APPLICATION NO.	FILING DATE	FIRST NAMED INVENTOR	ATTORNEY DOCKET NO.	CONFIRMATION NO.
10/070,501	03/07/2002	Vladimir Kliatzkin	P-2684-US	7024
27130	7590	10/25/2004		
EITAN, PEARL, LATZER & COHEN ZEDEK LLP 10 ROCKEFELLER PLAZA, SUITE 1001 NEW YORK, NY 10020			EXAMINER ALEJANDRO, RAYMOND	
			ART UNIT 1745	PAPER NUMBER

Office Action Summary

DETAILED ACTION

FIG. 18

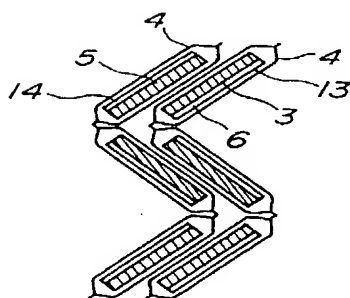
Honda et al disclose a rectangular battery including a plurality of cathode plates and anode plates alternately superposed via a separator to face each other. The cathode plates and the anode plates are consecutively packed with the separator and being folded at a separator fusing portion between the plates (ABSTRACT). It is disclosed that the anode plate is formed by a copper foil having both or one side thereof coated with a mixed anode agent; the separator is composed of a polymeric material and the rectangular battery has at least the cathode plates or the anode plates respectively packed with the separator, intrusion of the powder of the cathode plate and the anode plate into each other is prevented (COL 2, lines 25-38). It is disclosed that the layered product formed by the electrode plates and the separator is inserted into a rectangular battery casing and then a liquid electrolyte is filled therein (COL 1, lines 15-20). It is disclosed the electrode are enveloped by or packed between the separators and the packed electrode plates being folded at the separator fusing portion (COL 1, lines 60-67).

Figures 18 and 20 below illustrate battery embodiments
